Dogger Bank South Offshore
Wind Farms

The Applicants' Response to the Marine Management Organisation's Deadline 9 Document

Document Reference: 20.2

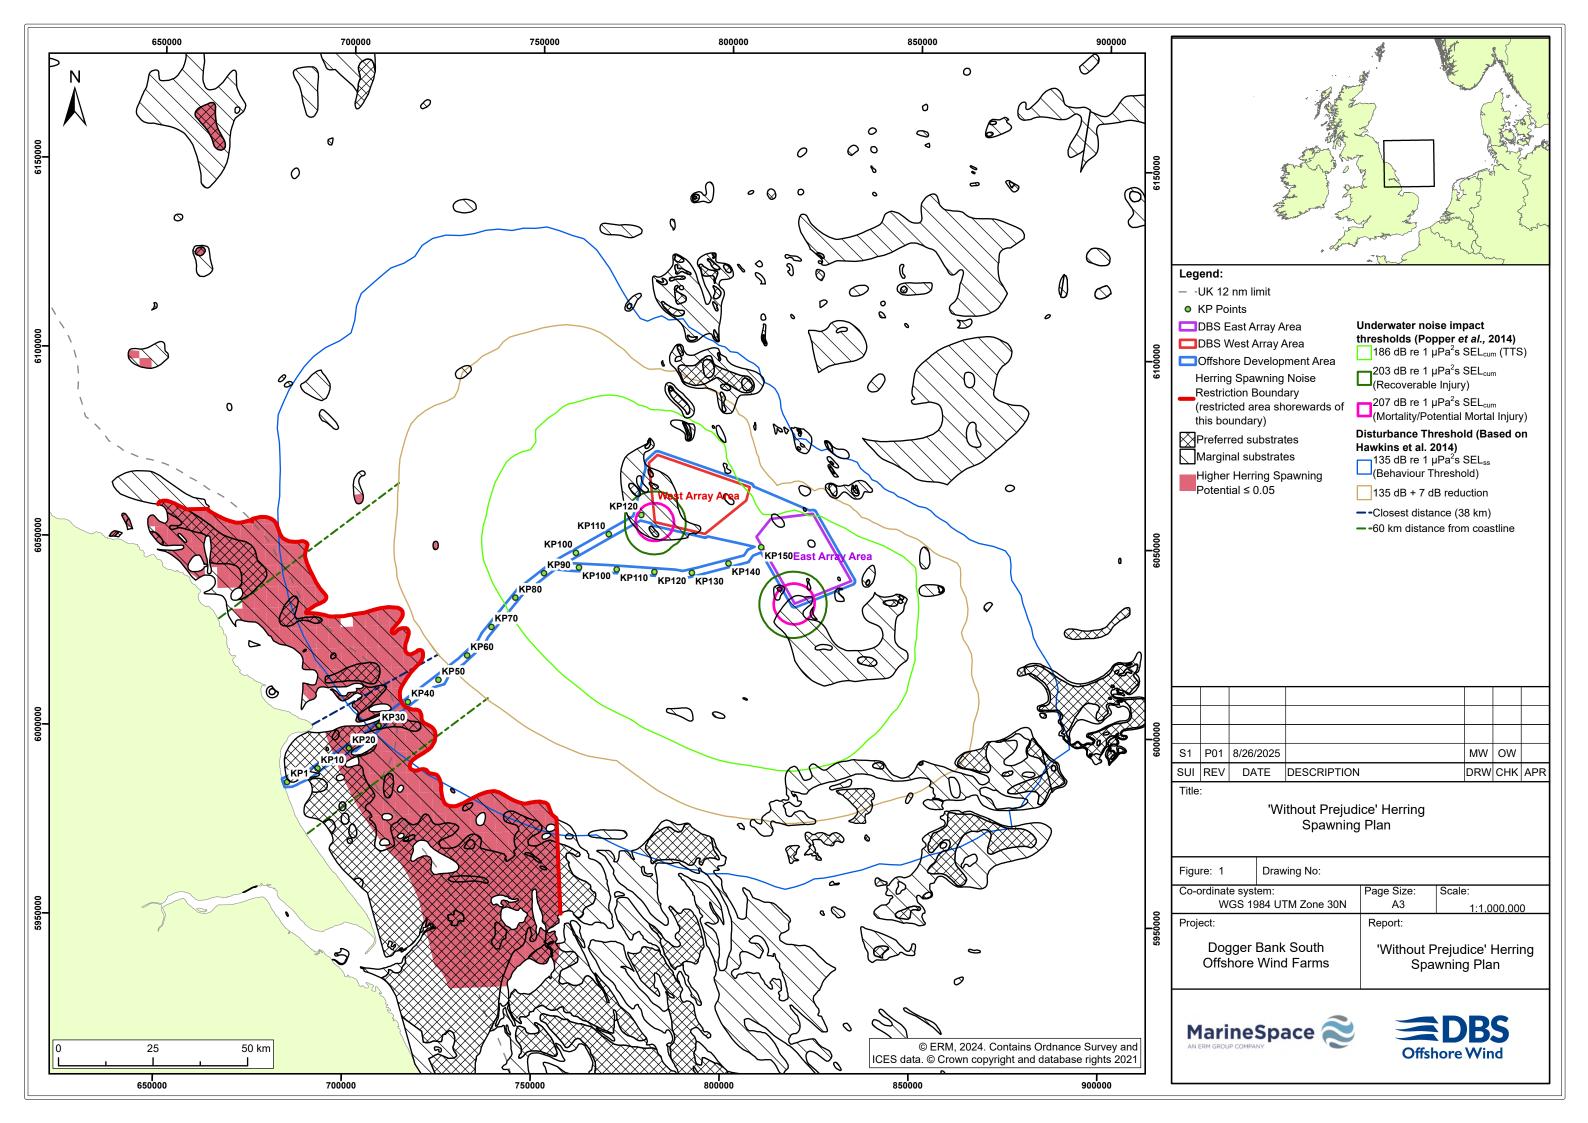
The wording presented within Point 4 of the proposed licence condition prevents any overlap of the 135dB noise contour with the Herring Spawning Noise Restriction Boundary. As a result, significant noise mitigation to prevent this overlap is necessary should piling be undertaken during the herring spawning season. Modelling indicates that a reduction of 7 dB is the minimum requirement to ensure no overlap occurs, as presented in the figure by the "135dB + 7 dB reduction" contour.

In the absence of noise mitigation, the minimum distance between the coast and the 135 dB contour is ~9.5 km. A 7 dB reduction will result in a minimum distance between the coast and the 135dB + 7 dB reduction contour of ~38 km at Flamborough Head, as indicated on Figure 1. To the north and south of Flamborough Head, this distance increases rapidly, reaching in excess of 60 km at 37 km to the north of this minimum corridor width and 22 km to the south of this minimum corridor. Thus, the noise mitigation required to meet the prescriptions of Point 4 of the without prejudice herring restriction will create a herring migration corridor approximately four times wider than in an unmitigated scenario at its narrowest, with this corridor widening to six times the width of the unmitigated corridor over a relatively short distance.

Therefore, the noise mitigation required to meet the prescriptions of Point 4 of the without prejudice herring restriction will secure a reduction of impact area across the 135db contour of 48% and will ensure that a wide, unimpacted herring migration corridor is maintained throughout the full extent of the herring spawning period. The benefits of the 'without prejudice' mitigation proposal significantly reduces the potential for disturbance effects to occur should herring populations transit eastward from northern spawning grounds before undertaking a southward migration.
